THE ILLINOIS STATE TOLL HIGHWAY AUTHORITY

DESIGN BULLETIN No. 20-05

SUBJECT: Concrete Median Barrier and Concrete Barrier Height Transition

CONCRETE BARRIER BASE, DOUBLE FACE, 44 INCH AND VARIABLE HEIGHT
 STANDARD C5-08

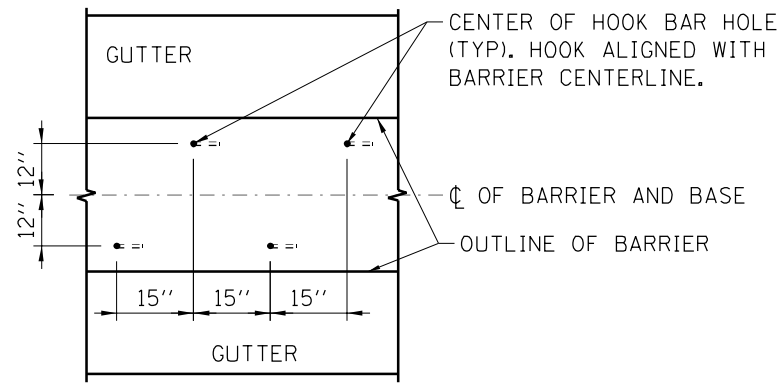
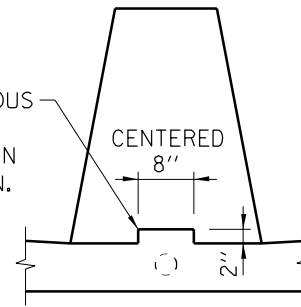
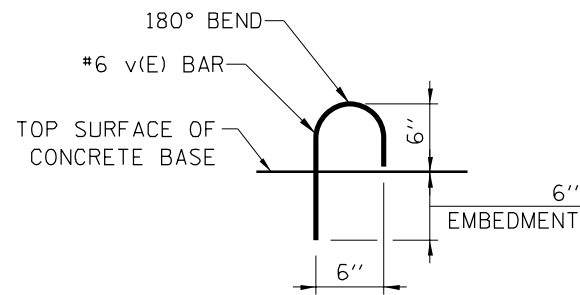
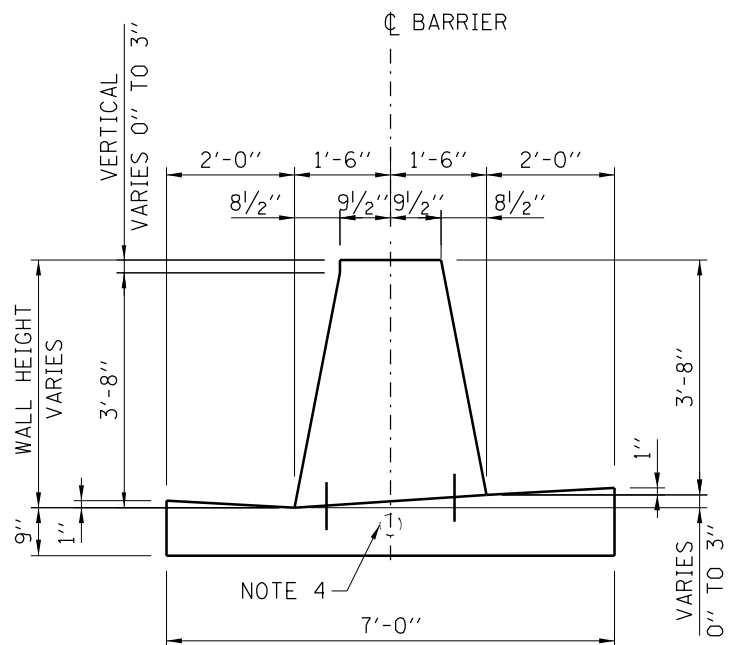
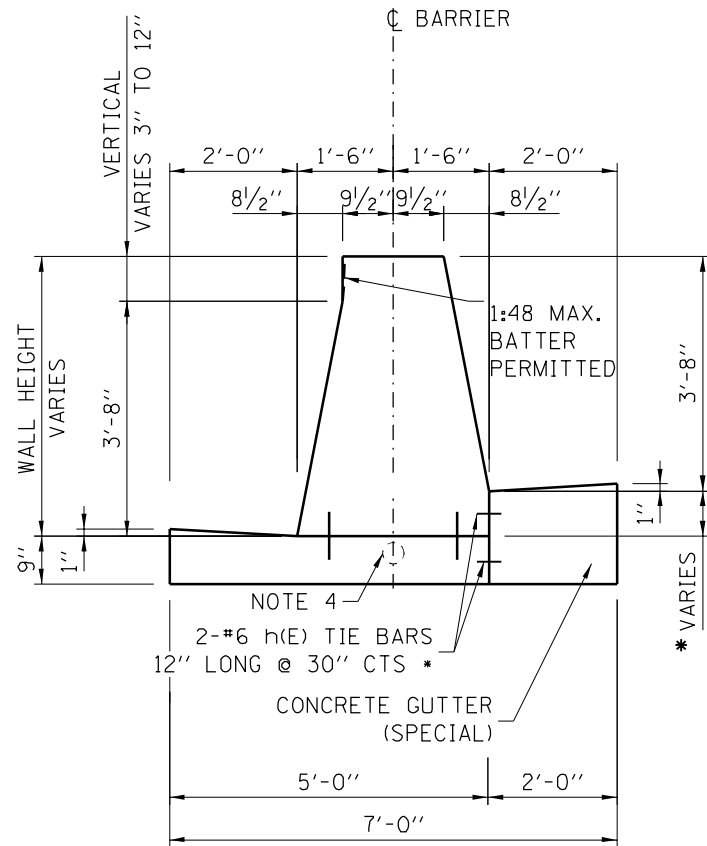
The Illinois Tollway Standard C5-07 has been revised and replaced by Standard Drawing C5-08 (attached) which has the following modifications:

- Sheet 1 of 1, Tie Bars and Keyway
 - The #6 vertical tie bars have been replaced with vertical #6 hook bars, designated as v(E).
 - The spacing of hook bars has been modified to 15" staggered side to side.
 - A hook bar detail and a placement layout plan has been added to the sheet.
 - An optional raised keyway and detail has been added to the standard. The raised keyway can be used in lieu of the hook bar when poured monolithic with the barrier base and when the barrier has an uninterrupted section length of 70' minimum, as described in the notes.
 - An allowable batter of 1:48 has been added to the vertical face of the variable height detail.

CONCRETE SHOULDER BARRIER HEIGHT TRANSITION, SINGLE FACE, TYPE SF-54
 STANDARD C18-00

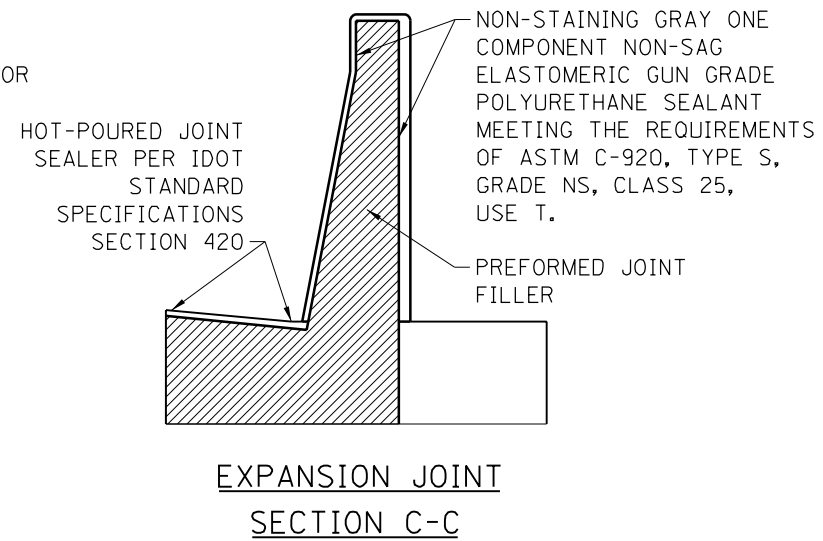
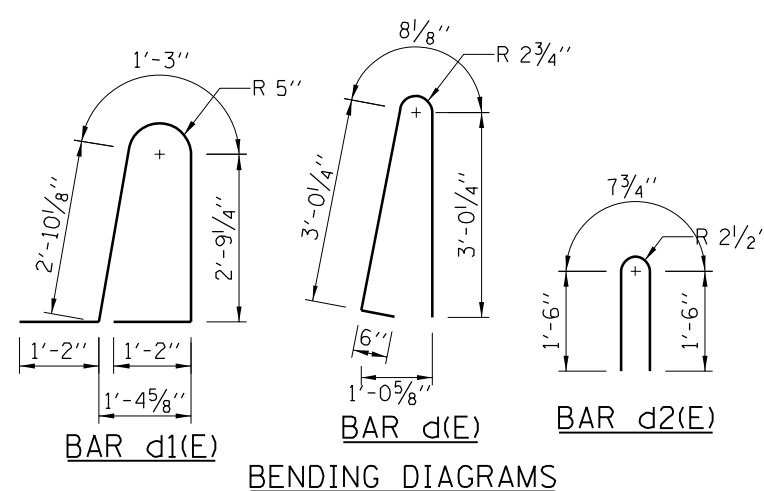
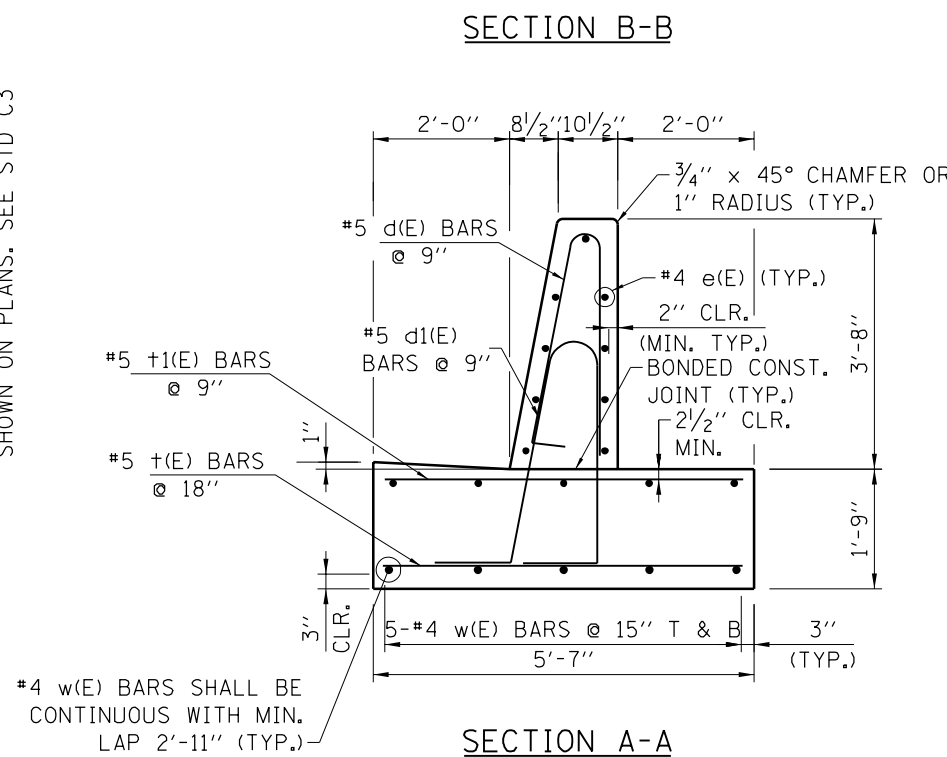
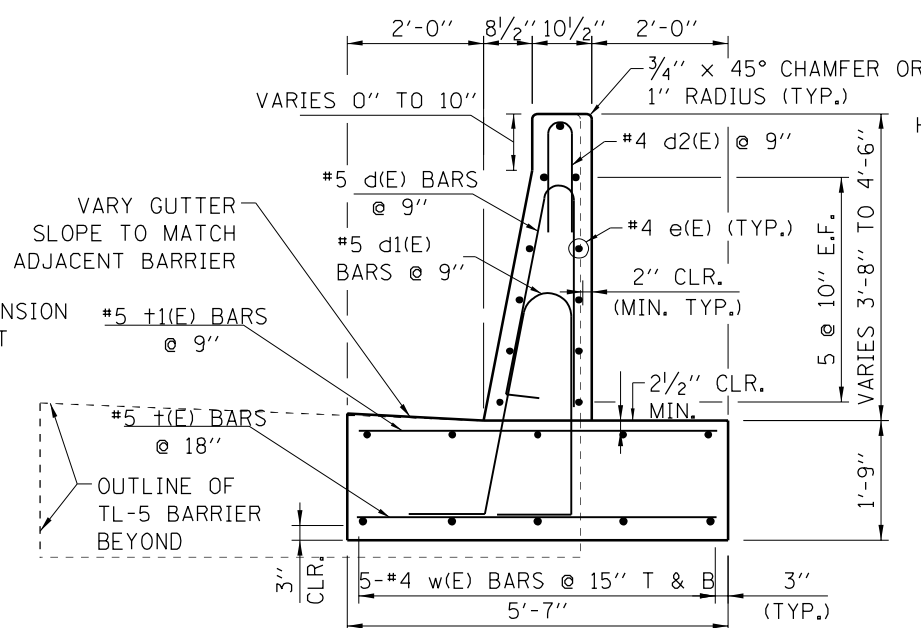
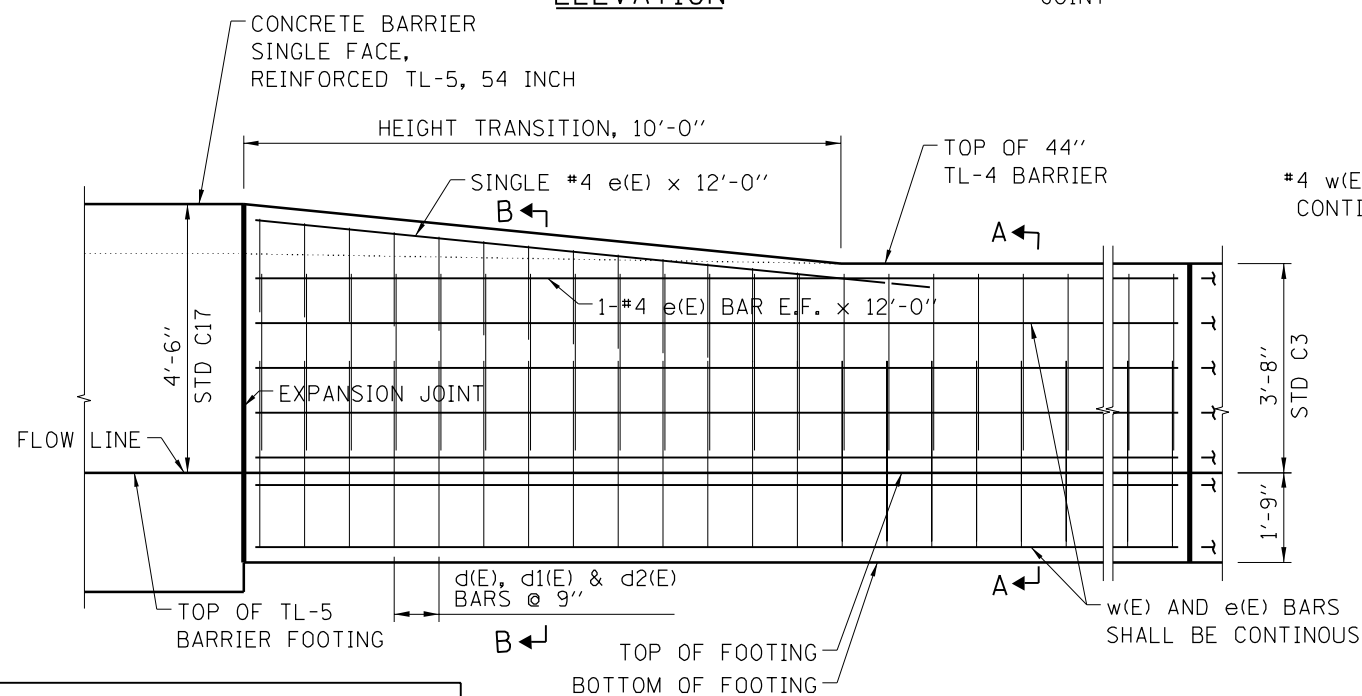
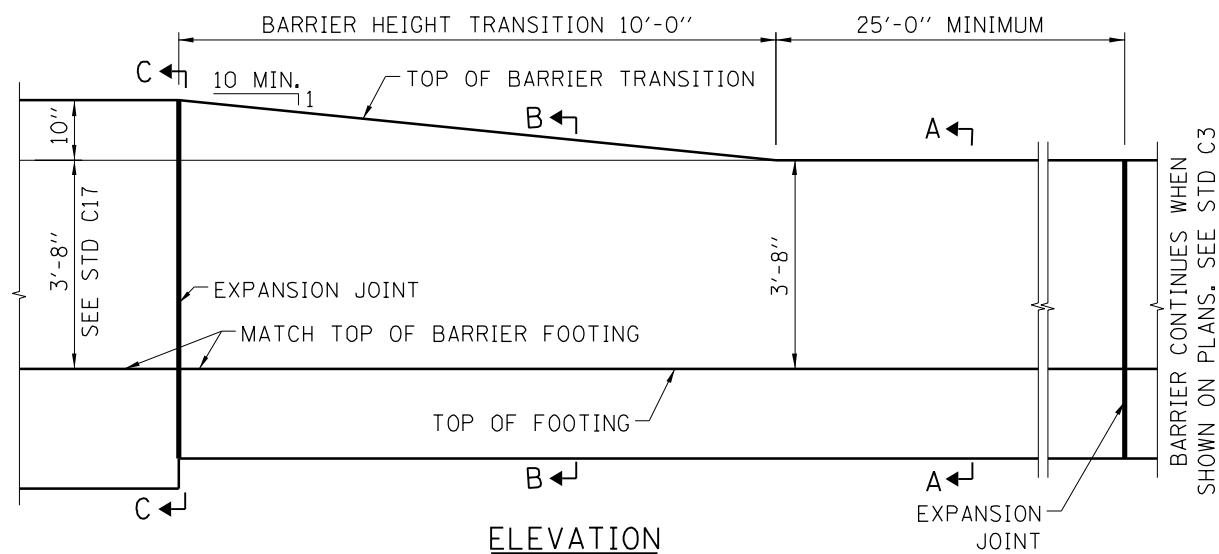
The new Illinois Tollway Standard C18-00 has been added to the Illinois Tollway, C Standards series (attached):

- Sheet 1 of 1, Concrete Shoulder Barrier Height Transition, Single Face, Type SF-54
 - This new standard should be included in projects where the height of TL-4 concrete barrier is required to transition from 44" tall (Standard C3) to 54" tall (Standard C17).
 - The height transition has a minimum length of 35'-0" and its upstream end, matches the section of the Concrete Barrier Single Face, Reinforced TL-4, 44 Inch (Standard C3).
